Application ref: DC/25/1269
Location: Land North of Guildford Road Bucks Green Rudgwick West Sussex
Proposal/Description: Outline Planning Application for up to 90 no. residential dwellings (including 40% affordable) all matters to be reserved apart from access.

Thank you for re-consulting with Place Services on the above Outline planning application. This letter sets out our consultation response on the landscape impact of the application and how the proposal relates and responds to the landscape setting and context of the site.

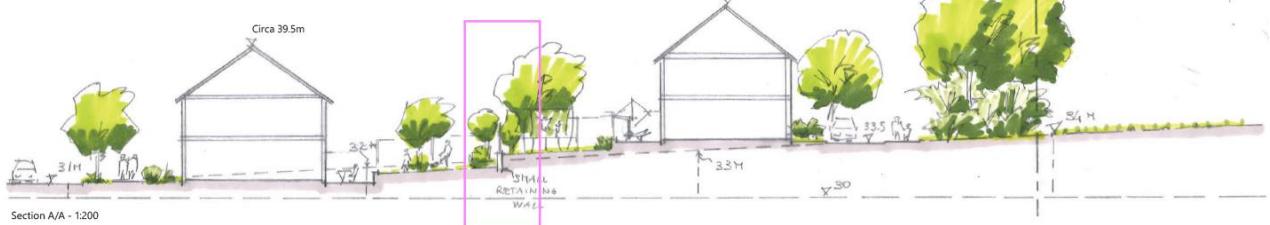
In response to para 1.1.4 of the Landscape Statement, we reiterate our reference to the Strategic Policy HA14 wording which states: "*In addition to meeting national and Local Plan requirements, development will be supported where proposals: Are limited to the southern part of the site as shown on the Policies map, with an agreed landscape treatment in the northern part of the site to minimise landscape impacts;*" The proposals, regardless of their

impact, are not limited to the southern portion of RD1 allocation site or the Application Site and therefore is not in line with Policy RD1.
